Access Compliance Report Public Rights-of-Way (Curb Ramps)

Main Street: EARLHAM_ST Cross Street: E_CHAPMAN_AVE Location: SW

ADA ID: RPAT210929144048 Ramp Type: Type 4 - Parallel Initial Pass/Fail: Pass Overall Compliance: No Severity Score: 0

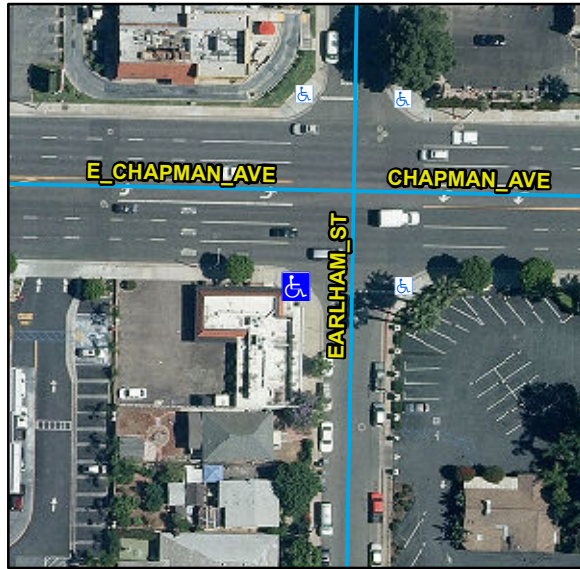
N/A	Ramp Inside Crosswalk 1	N/A	N/A	Ramp Inside Crosswalk 2	N/A
	Crossing 1 Slope (%)	4		Crossing 2 Slope (%)	4.8
	Crossing 1 Cross Slope (%)	3.8		Crossing 2 Cross Slope (%)	0.7
Yes	Gutter Ponding	No	No	Curb Slope	15.4
Yes	Gutter Lip Height (in)	0		Road Run Slope (%)	0.3
Yes	Gutter Run Slope (%)	2.7		Road Cross Slope (%)	5.2
Yes	Gutter Cross Slope (%)	0.4	Yes	Perpendicular Joint Present	Yes
Yes	Overall Surface Condition	Acceptable			
	Cross Gutter Present?	No		Spandrel Present?	No
	Replace Cross Gutter?	N/A		Replace Spandrel?	N/A

Remove & Replace Curb Slope.

R304.2.2, STD 1115
